Seismic Walkdown Checklist (SWC)

Equipment ID No. Q1R17B002 Equip. Class¹ 1

Equipment Description MCC 1B

Location: Bldg. AUXILIARY Floor El. 121 Room, Area 209

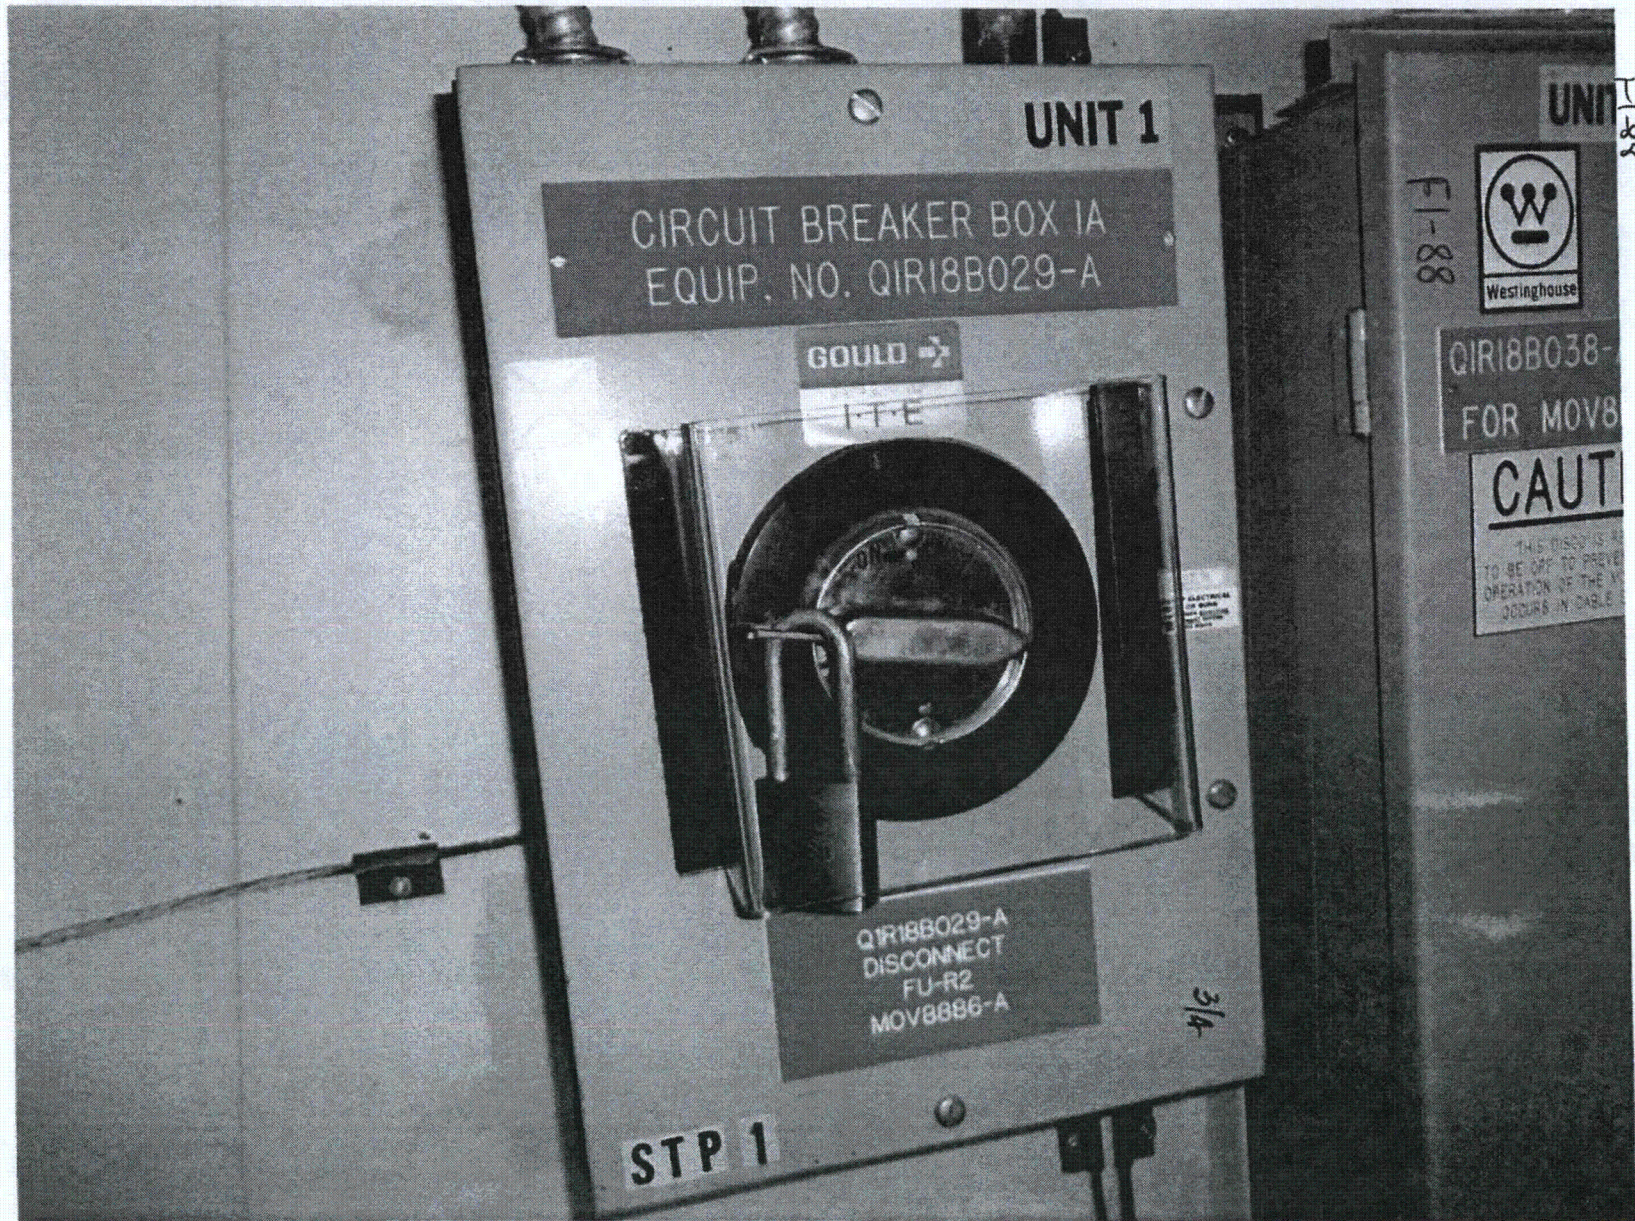
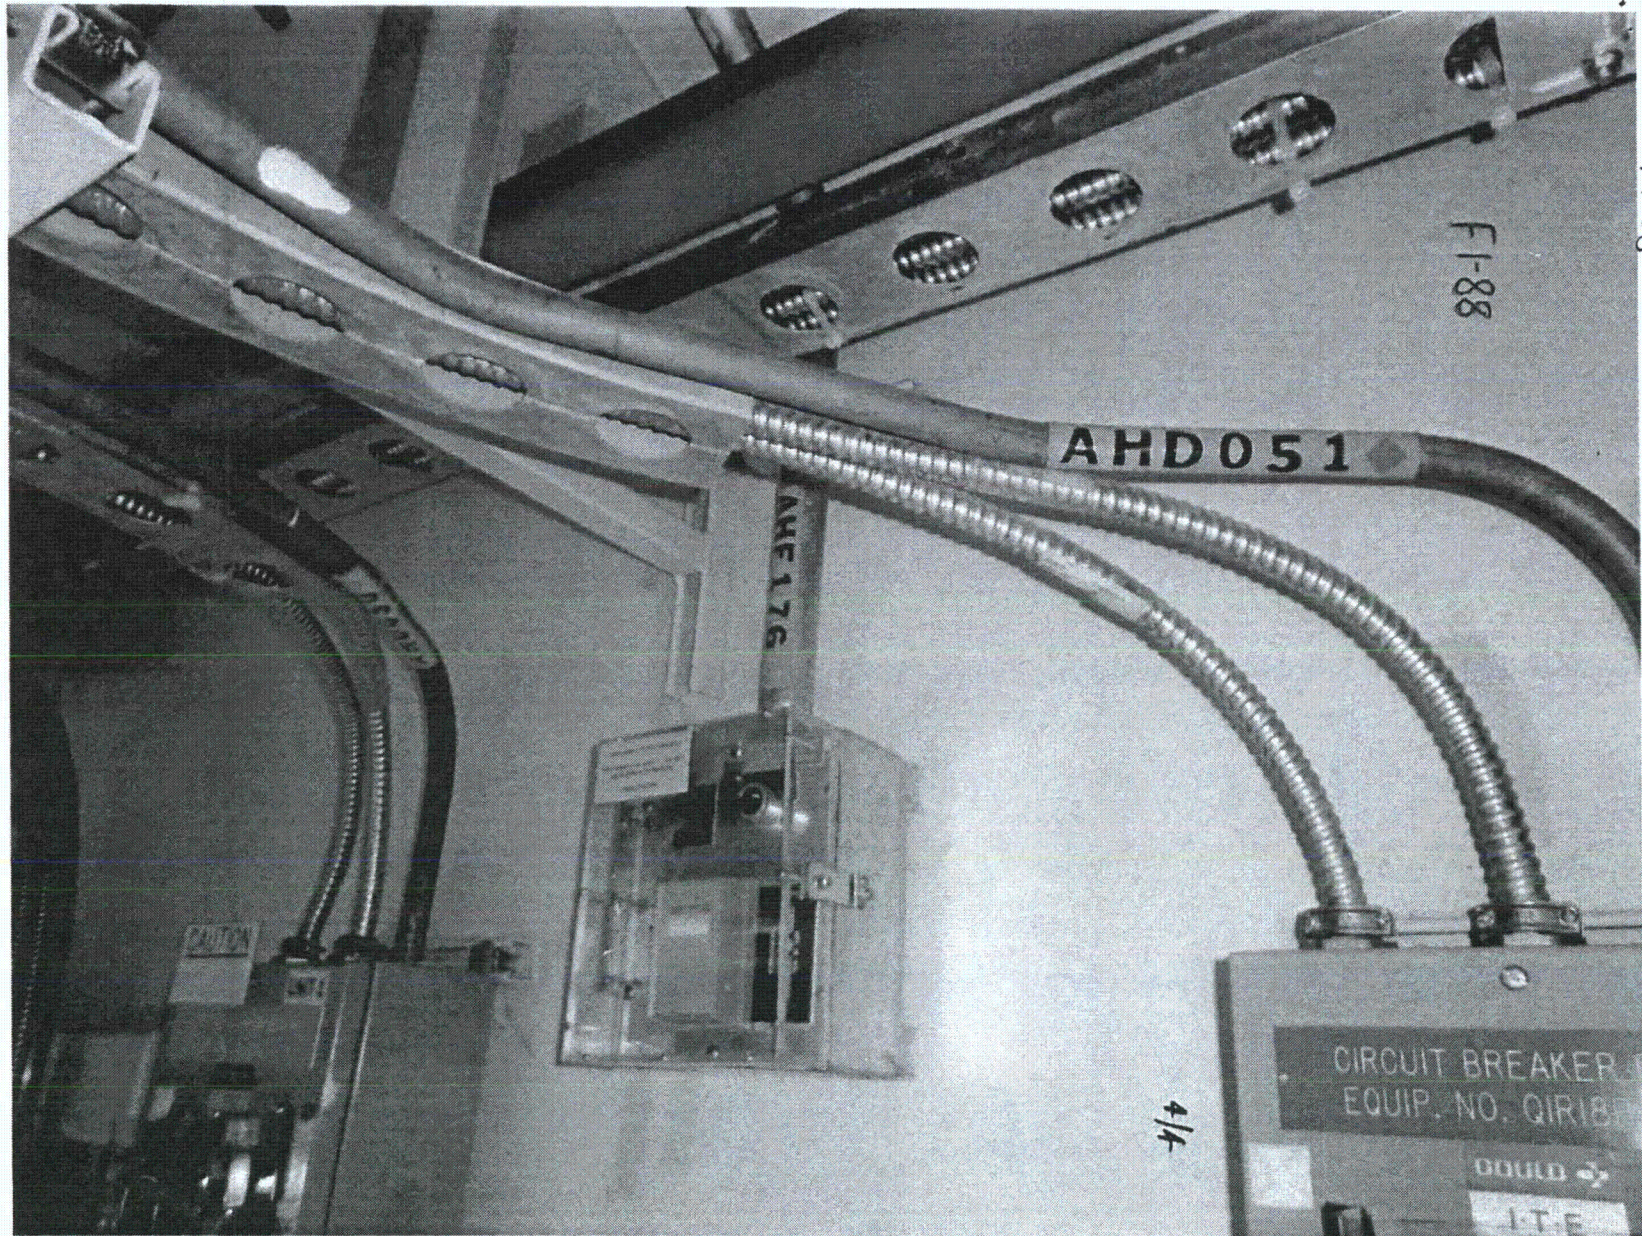
Conduit AHJ051 is not a flex conduit, however IT is attached to cable tray supports attached to the same wall the switch is firmly attached to. There is therefore no seismic interaction issue,

Since the two would act together during a seismic event, OKAY

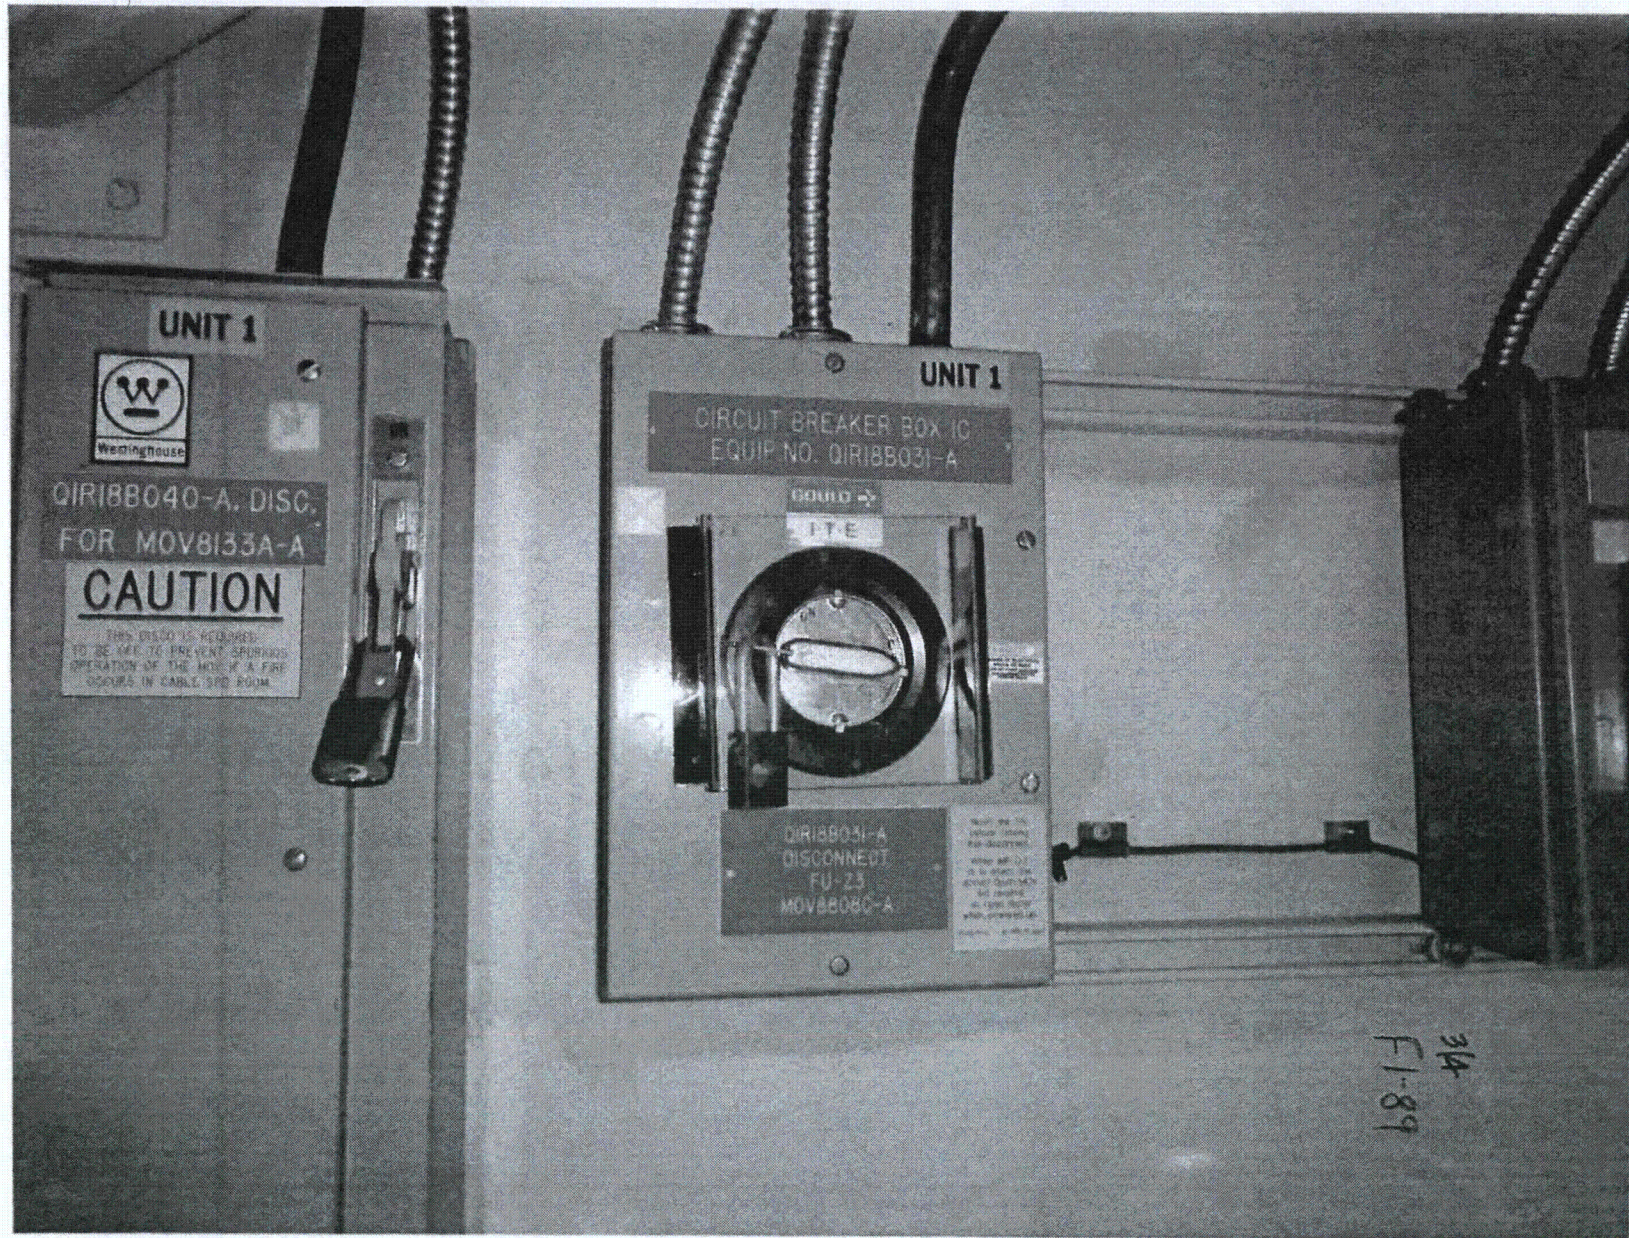
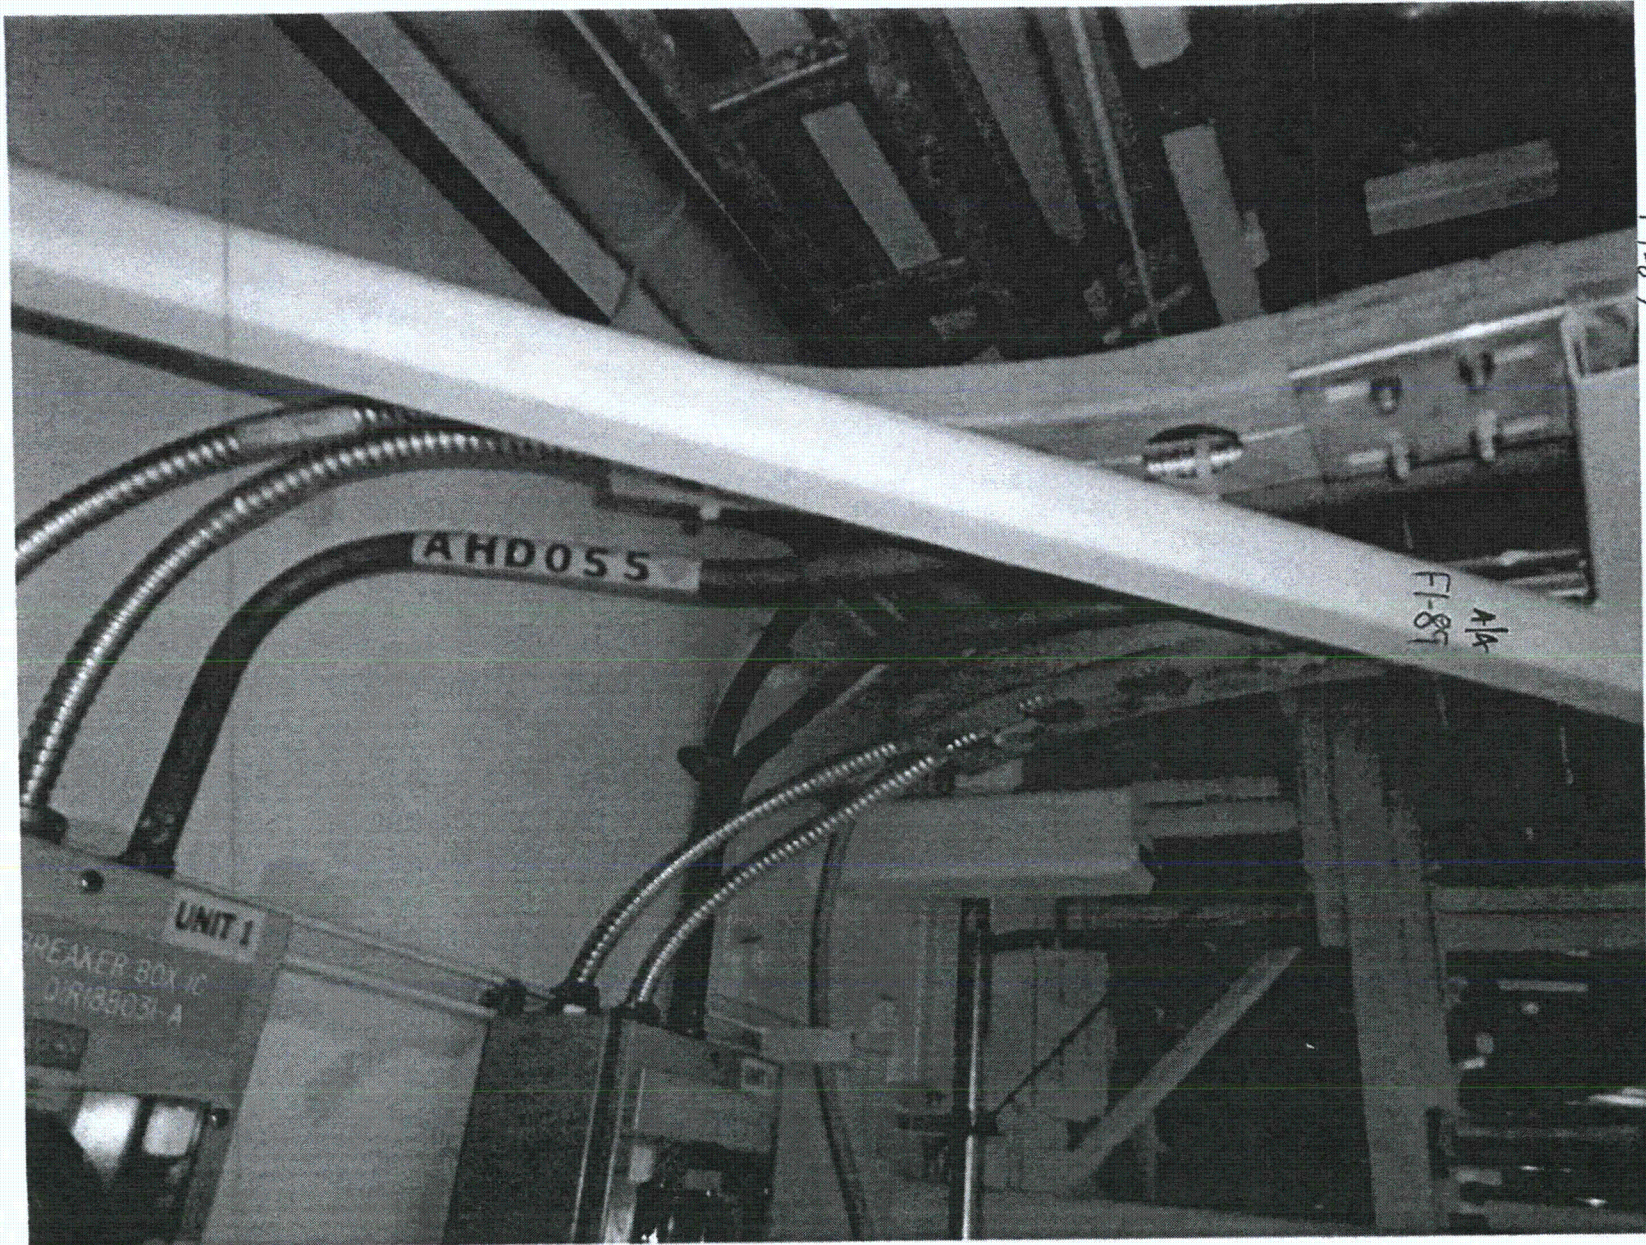
CONDUIT AH0055 is not a Flex conduit however it is attached to cable tray supports attached to the same wall as the box is firmly attached to - there is no seismic interaction issue since,

↳ the two would act together during a seismic event. OKAY
